To: Kristopher Byrd, Well Construction and Compliance Section Manager
From: Travis Kelly, Well Construction Program Coordinator
Subject: Review of Water Right Application G-19027
Date: March 31, 2021

Application # G- 19027

TO: **Application G- 19027**

TO: Water Rights Section Date 3/11/2021
 FROM: Groundwater Section Joe Kemper
Reviewer's Name
 SUBJECT: Application G- 19027 Supersedes review of na
Date of Review(s)

Stream Depletion Modeling (Hunt, 1999)

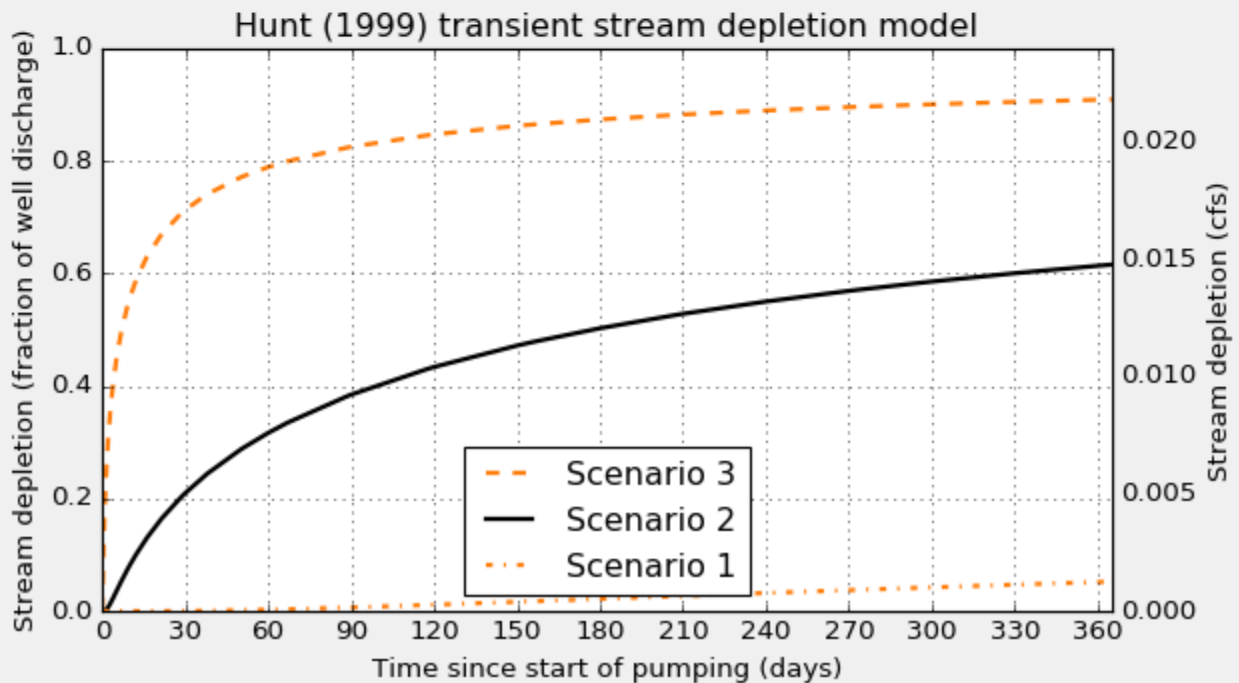
Basis for impact evaluation: Stream depletion to Williams Creek is estimated using the Hunt (1999) analytical model using parameters representative of bulk aquifer properties. A pumping rate of 0.024 cfs is used to represent the total volume of water that would be pumped from JOSE 9971 under G-19027 and Certificate 66521 (17.5 AF) pumped over 365 days.

C6. **SW / GW Remarks and Conditions:** The applicant's well accesses an aquifer that is determined to be hydraulically connected to Williams Creek. The Division 9 review is done considering both the requested rate under application G-19027 and the current Certificate 66521 (see table below). There is not a preponderance of evidence that the proposed use has the Potential for Substantial Interference (PSI) as per OAR 690-009.
